APPLICATION NO.	FILING DATE	FIRST NAMED INVENTOR	ATTORNEY DOCKET NO.	CONFIRMATION NO.
10/573,543	03/27/2006	Danut Bogdan	2003P13768	7334
24131	7590	11/17/2006	EXAMINER	
LERNER GREENBERG STEMER LLP			CRUZ, LESLIE PILAR	
P O BOX 2480			ART UNIT	PAPER NUMBER
HOLLYWOOD, FL 33022-2480			2826

Office Action Summary	Application No. 10/573,543	Applicant(s) BOGDAN ET AL.	
	Examiner Leslie P. Cruz	Art Unit 2826

DETAILED ACTION***Drawings***

FIG. 9 (b)

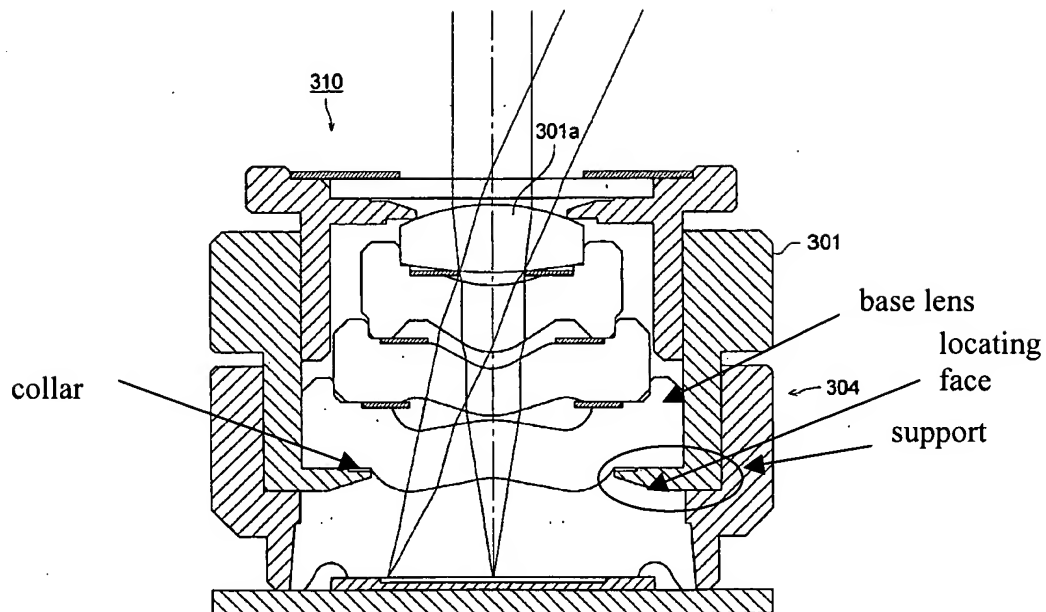
With respect to claim 10, Tansho (e.g. Figs. 1-2, 6 and 9 (b)) discloses an optical module comprising: a circuit carrier [PC]; a semiconductor element disposed in a housing [304] disposed on the circuit carrier, the housing of the semiconductor element, at least in sections thereof, having a support (see figure below) formed thereon; and a lens unit [301a] configured for projecting electromagnetic radiation onto the semiconductor element; wherein the semiconductor element and the lens unit are formed in two parts, and the lens unit is supported on the support formed on the housing of the semiconductor element.

Tansho (e.g. Fig. 9) discloses the support is formed to be tilt-free.

Tansho (e.g. Figs. 6 and 9) further discloses the support is a ring collar.

Tansho (e.g. Fig. 9) discloses the lens unit includes a base lens (see figure above) and the lens unit is supported on the base lens.

Tansho (e.g. Fig. 9) discloses the base lens includes a surface section formed to correspond to the support, at least in sections thereof, and wherein the surface section is positioned on the support formed on the housing of the semiconductor element.

With respect to claim 15, Tansho discloses the optical module according to claim 13. Tansho (e.g. Fig. 9) further discloses the base lens has a collar, at least in sections thereof, formed to correspond substantially to a locating face formed on the support.

With respect to claim 19, Tansho discloses the optical module according to claim 10. Tansho (e.g. Fig. 9) further discloses the support is formed with a locating face, at least in sections thereof.

With respect to claim 20, Tansho discloses the optical module according to claim 19. Tansho (e.g. Fig. 9) further discloses the locating face (see figure above) of the support is formed with a taper from the semiconductor element in a direction of an optical axis of the optical module.

With respect to claim 21, Tansho discloses the optical module according to claim 20. Tansho (e.g. Fig. 9) further discloses the taper is conical.
